**Economic and Social Council**Distr.: General
8 February 2021

World Forum for Harmonization of Vehicle Regulations**Working Party on Lighting and Light-Signalling****Eighty-fourth session**

UN Regulation No. 48 (Installation of lighting and light-signalling devices):**Proposals for new series of amendments to UN Regulation No. 48****Proposal for a new 08 series of amendments to UN
Regulation No. 48****Submitted by the expert from the Special Interest Group***

Model A

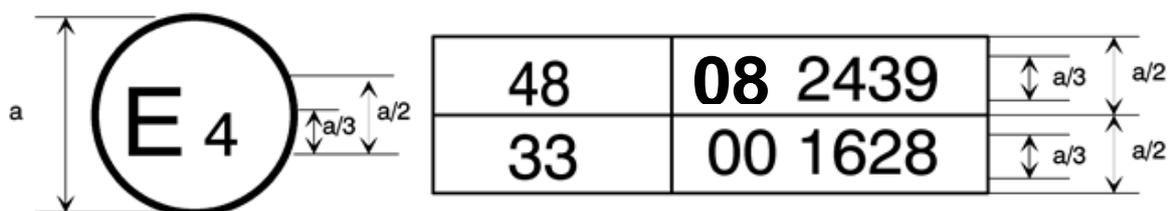
Annex 2, amend to read:

The above approval mark affixed to a vehicle shows that the vehicle type concerned has, with regard to the installation of lighting and light-signalling devices, been approved in the Netherlands (E4) pursuant to UN Regulation No. 48 as amended by the **08** series of amendments. The approval number indicates that the approval was granted in accordance with the requirements of UN Regulation No. 48 as amended by the **08** series of amendments.

28. Editorial changes were introduced to update the number of the series of amendments in the marking examples.
